DESIGN REVIEW BOARD RECORD OF DECISION

Meeting Date August 22, 2024 **DRB Case No.** PDR-002779-2024

Address 652 Robin Glen Drive

DESIGN REVIEW STAFF REPORT – HILLSIDE SINGLE FAMILY

Proposed Pool
Cabana Elevations

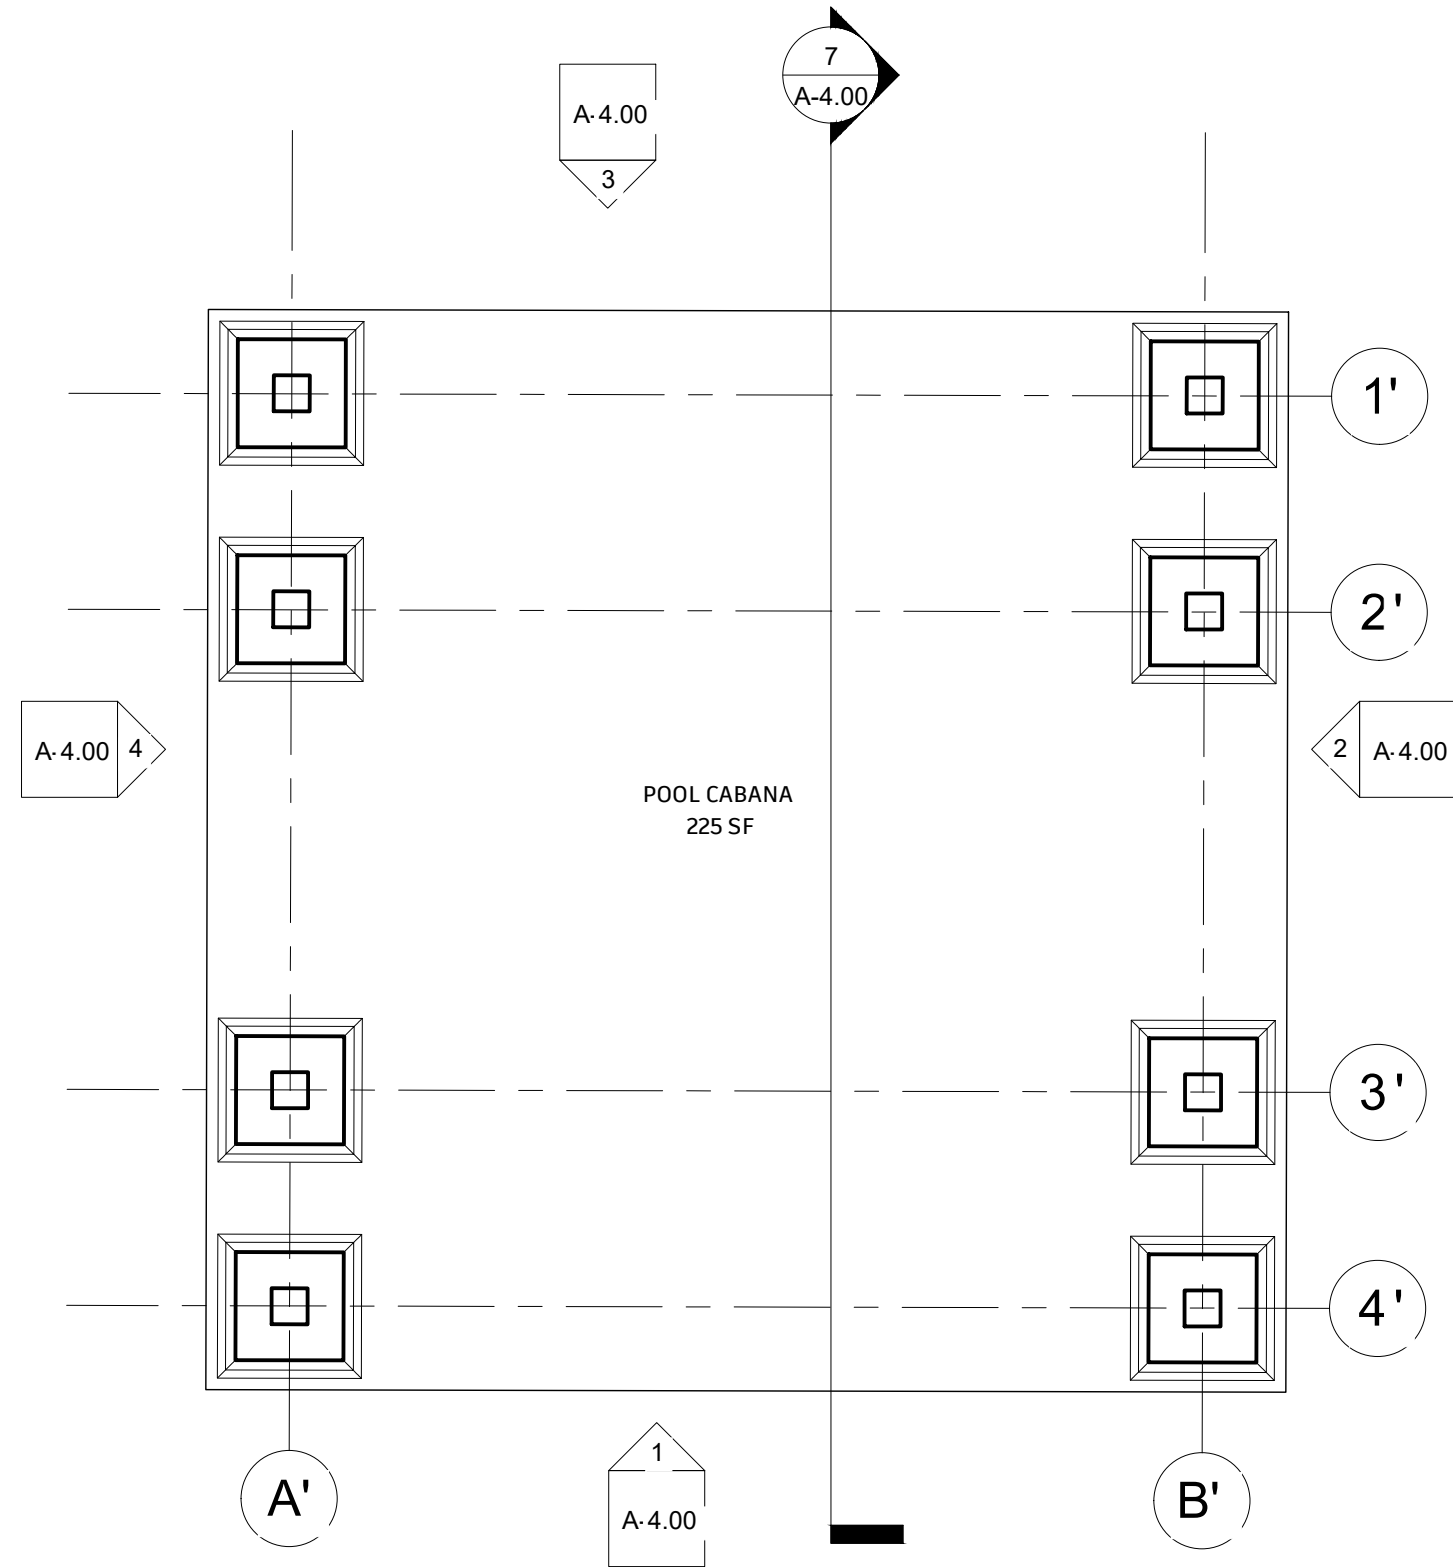
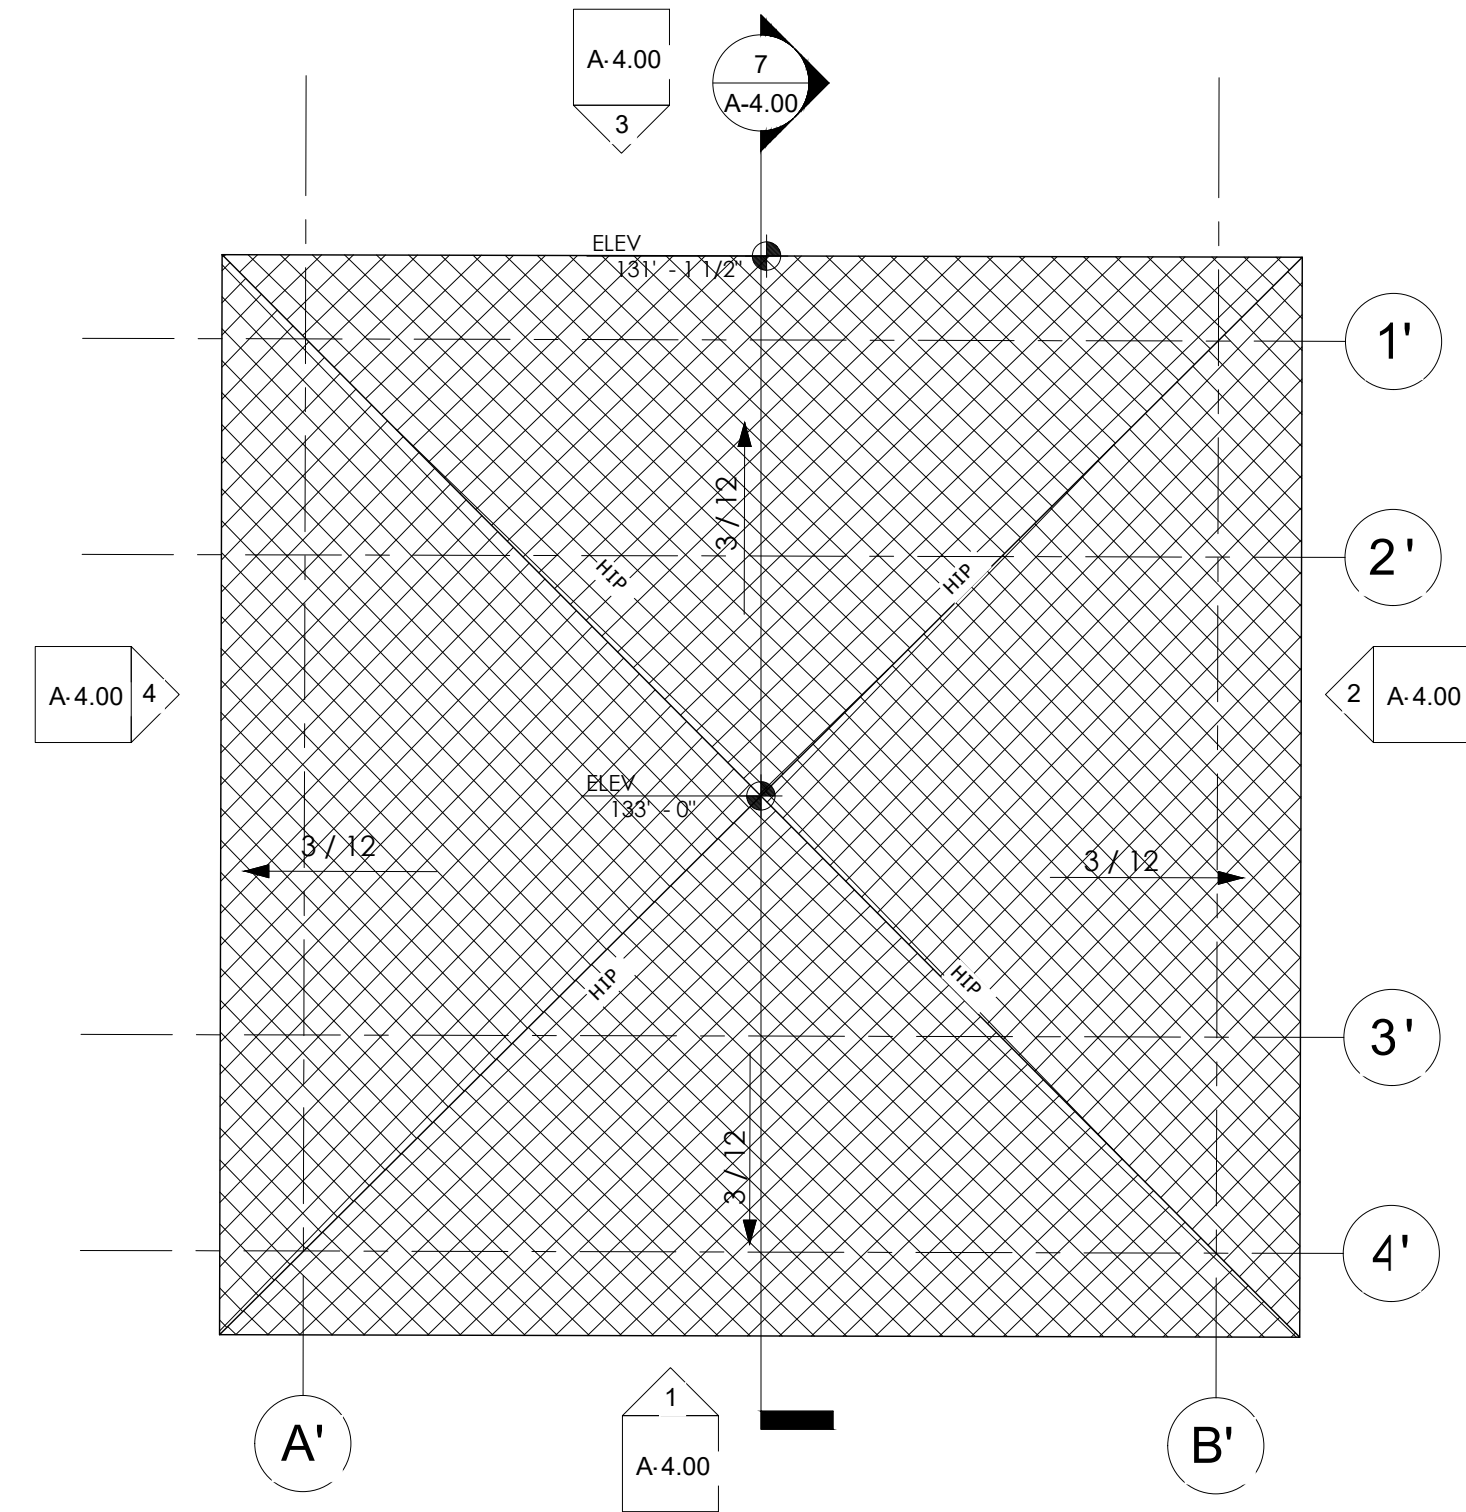
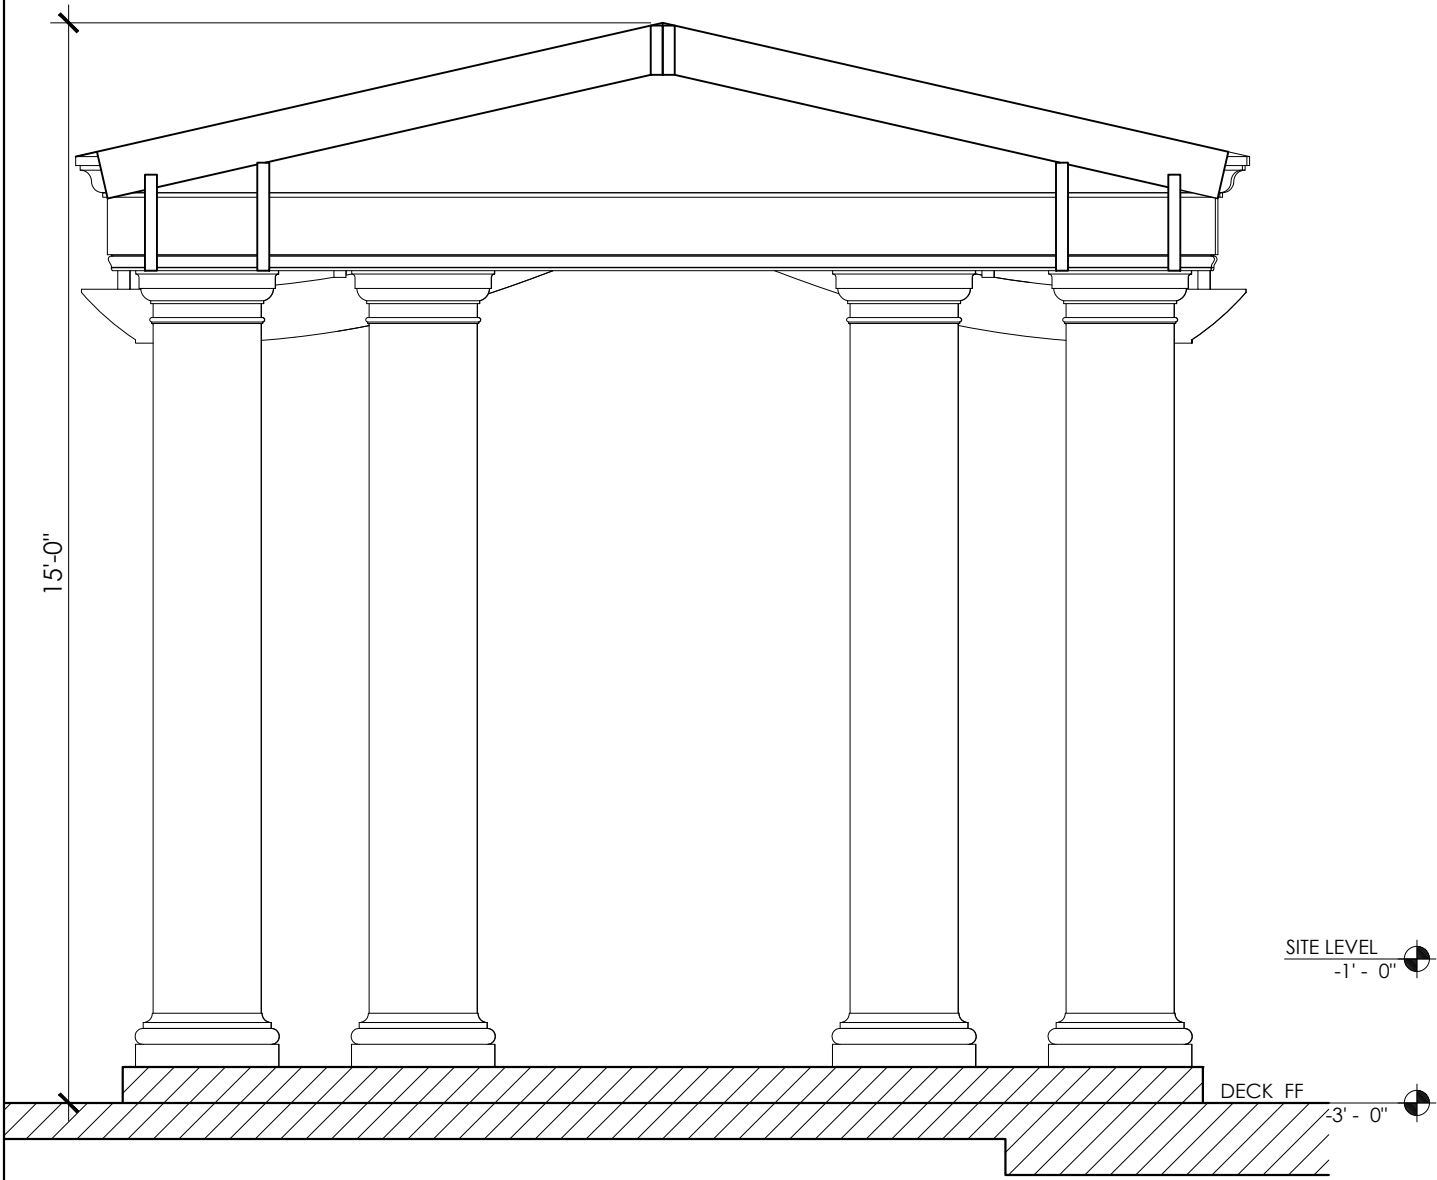
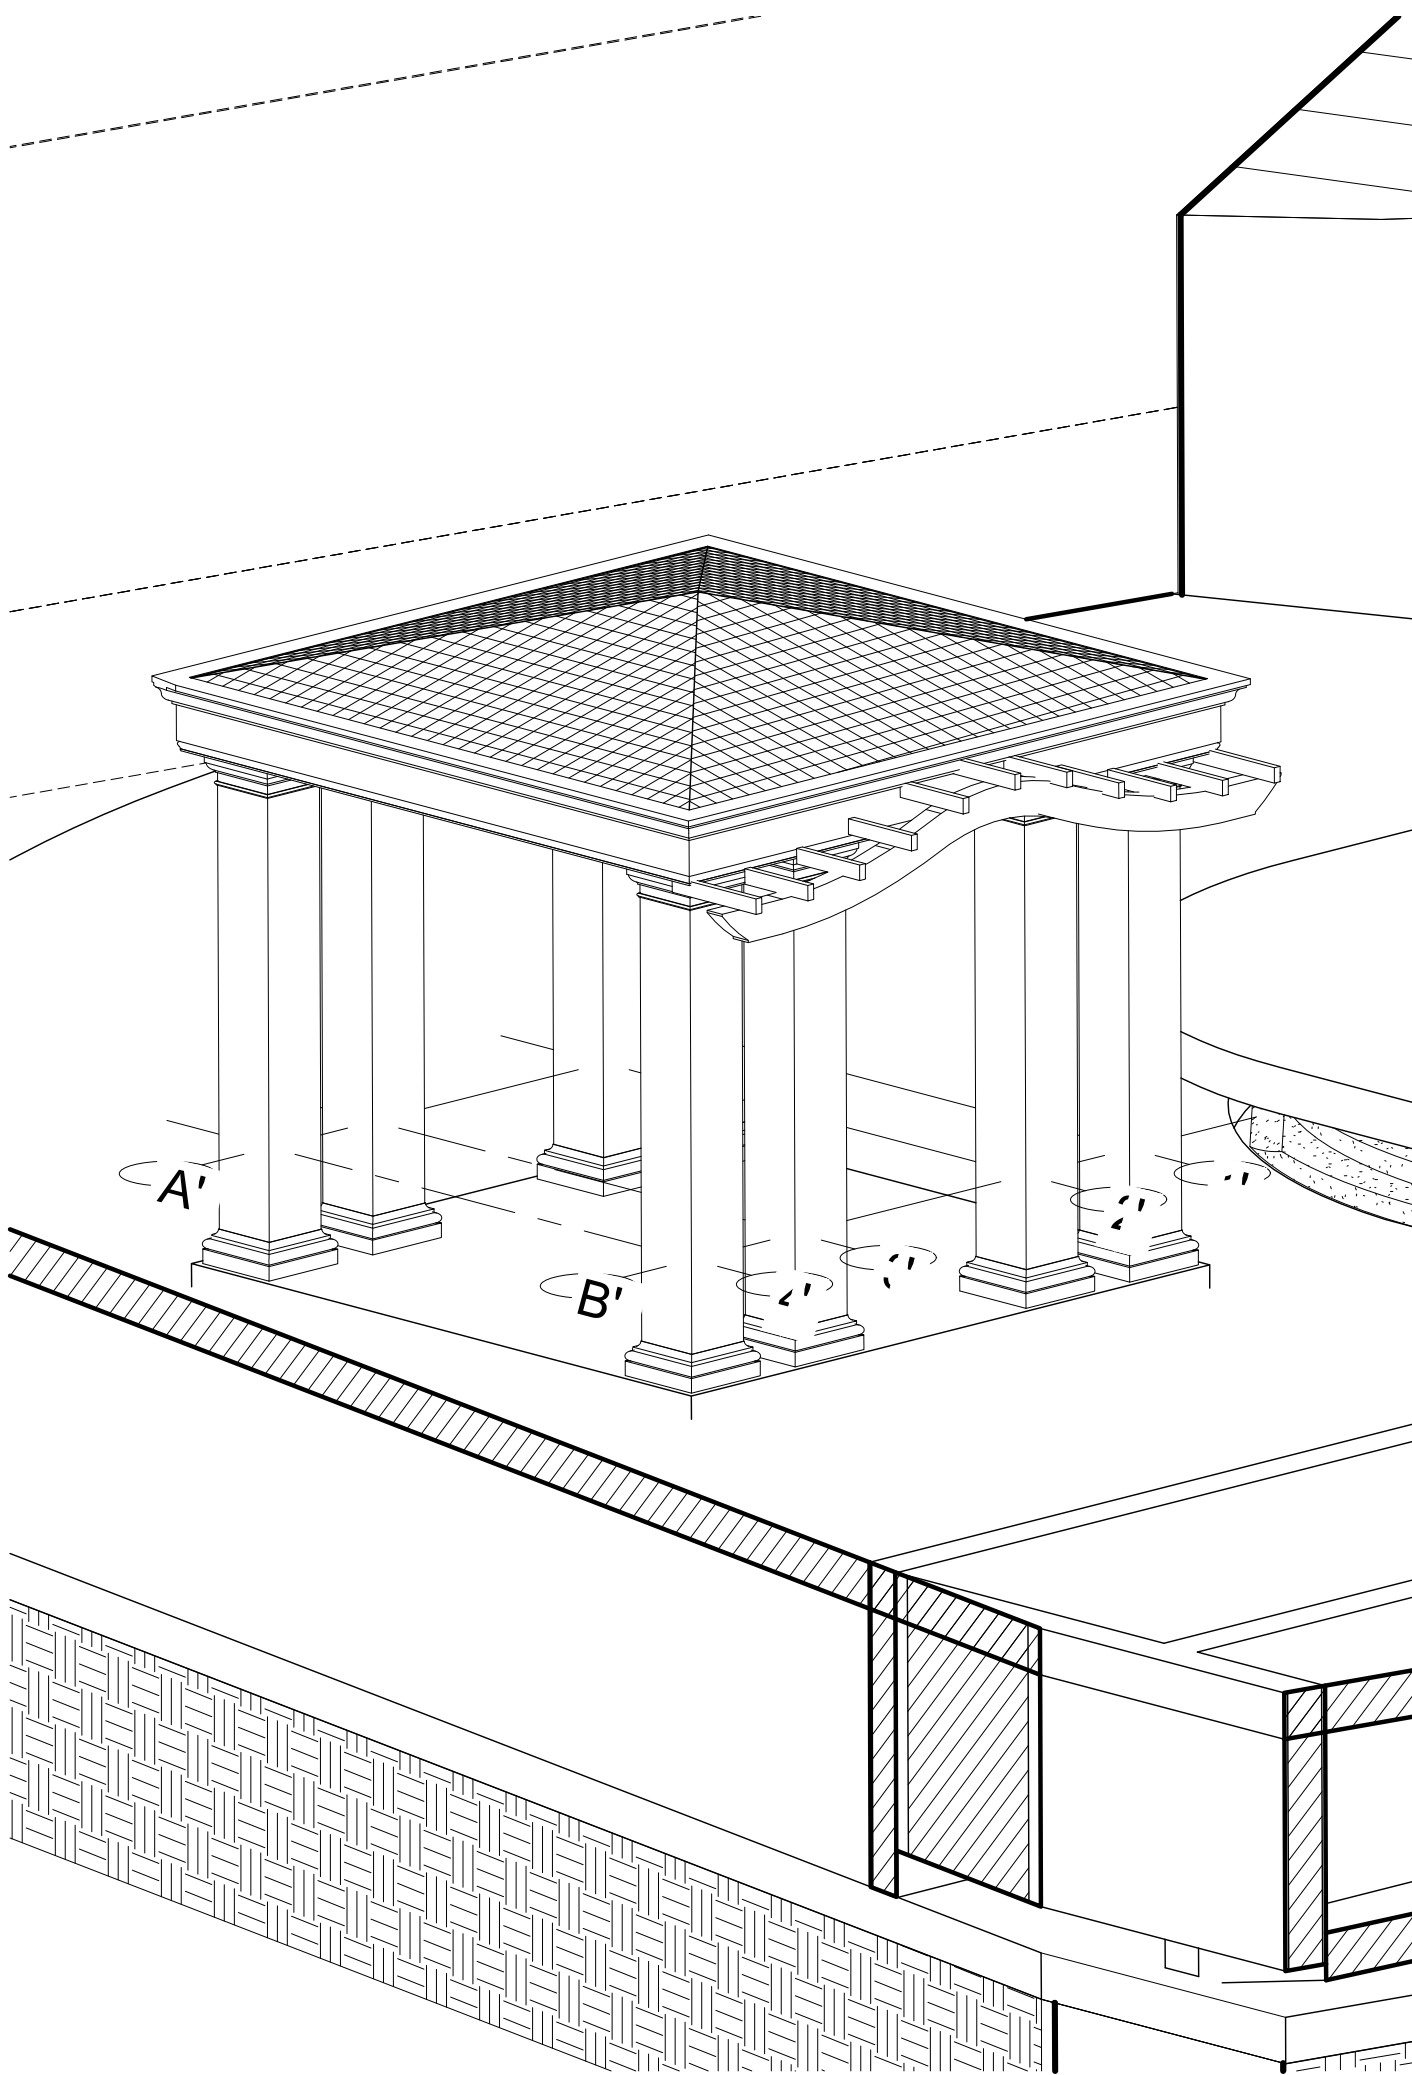
1. Reduce the proposed floor to ceiling height at the first and second floor; and lower the heights of the garage and pool cabana to provide better proportions and avoid the sense of monumentality as well as minimize the visual impact.
2. Redesign the facades that are visible from the street, particularly the east façade, to reduce the boxy appearance and monumentality of the house by stepping back the
